Request for Class II Permissive Change

FCC ID: APIJBLFLIP

Date: Nov 29, 2012

Antenna

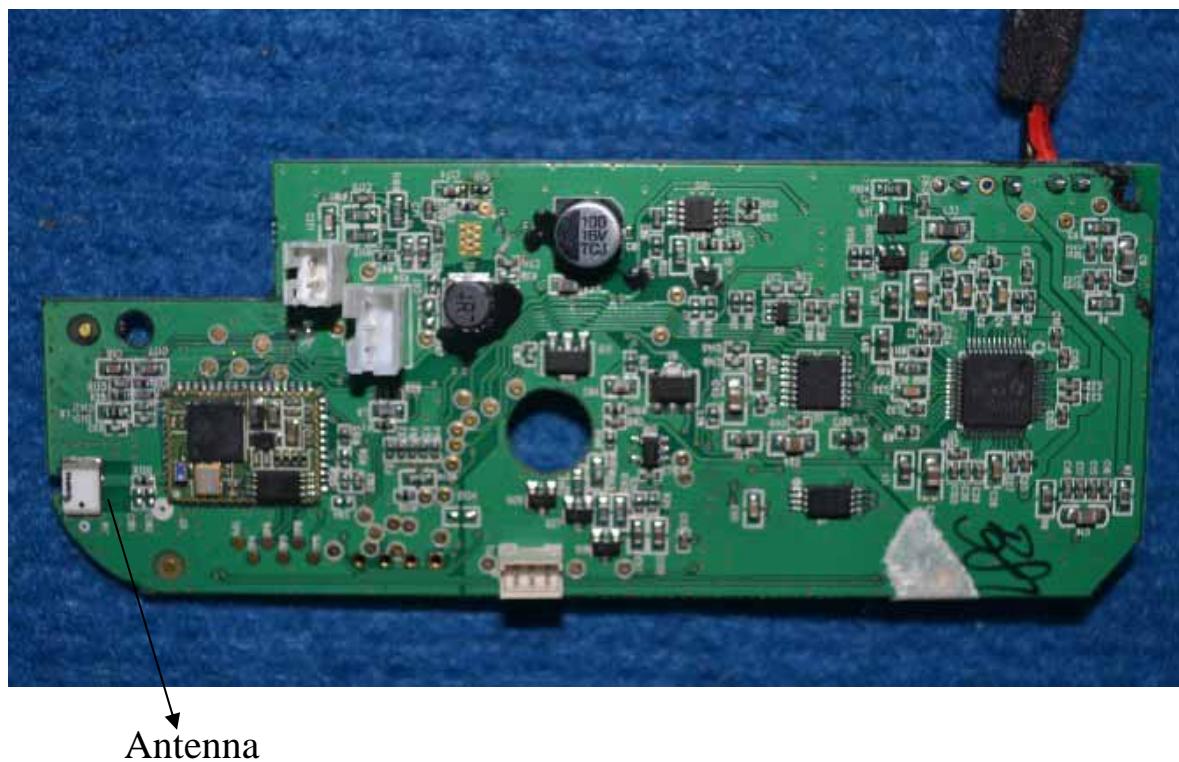
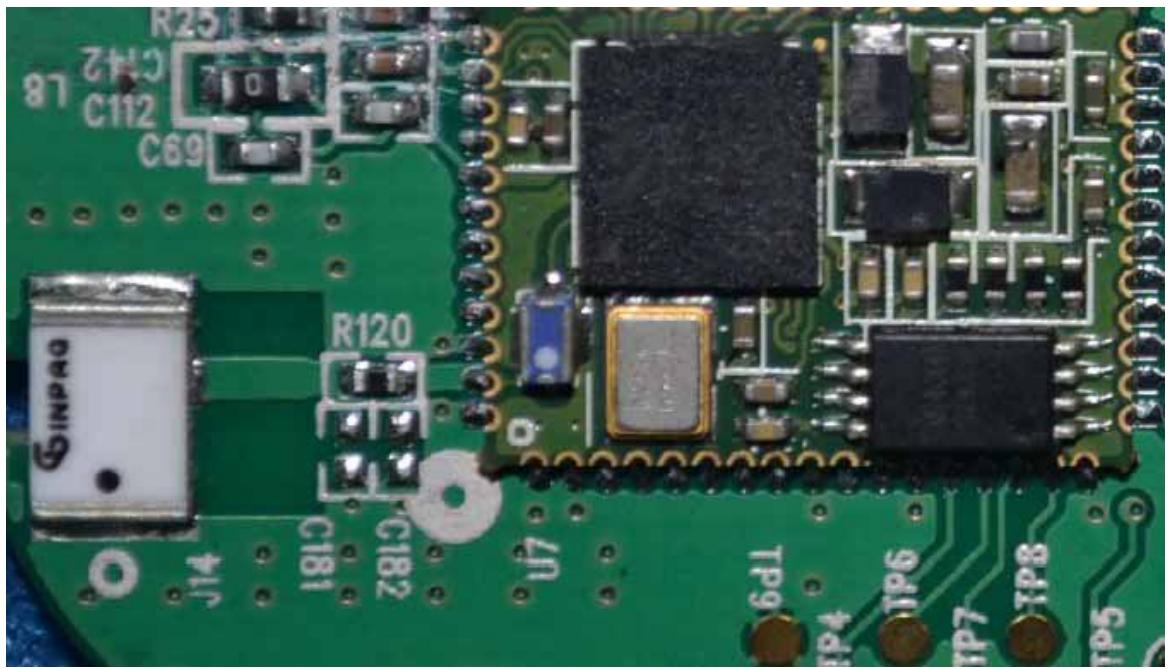
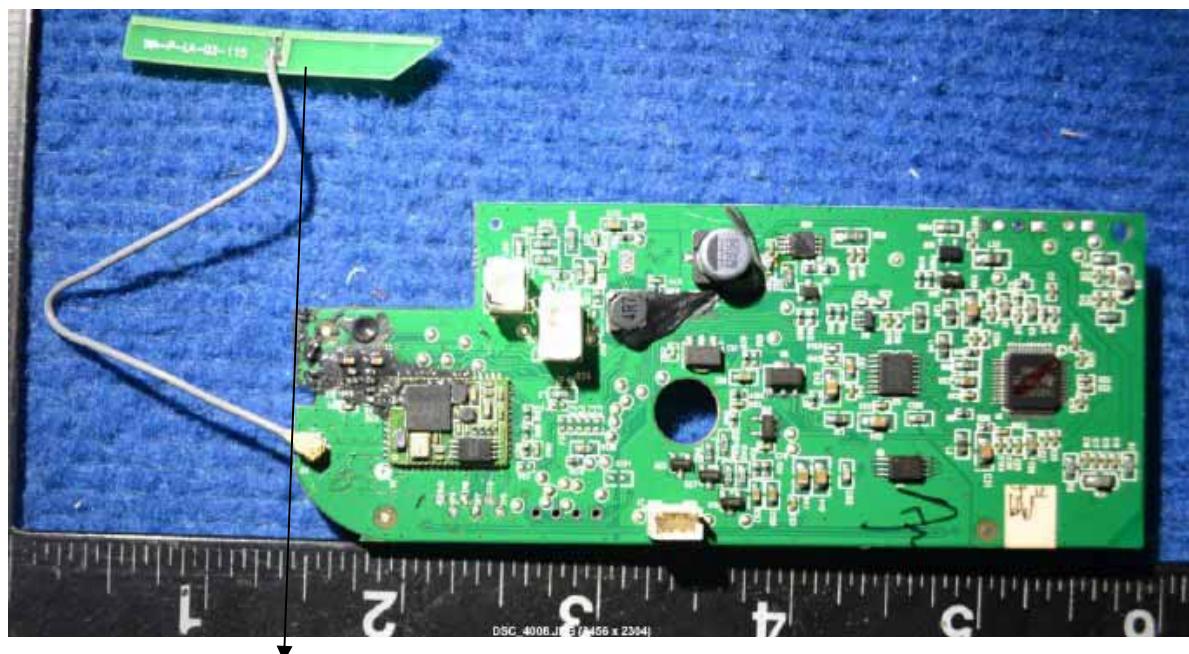
1: Change antenna so as to obtain better reception.

Antenna Type	Antenna gain	Antenna model	Antenna manufacturer
Before change	Ceramics	3.0 dBi	ACA-5036-A2-CC-S	INPAQ Taiwan
After change	Coaxial Cable	1.57dBi	WA-P-LA-03-115	INPAQ

Antenna of original equipment

Antenna of Class II permissive change
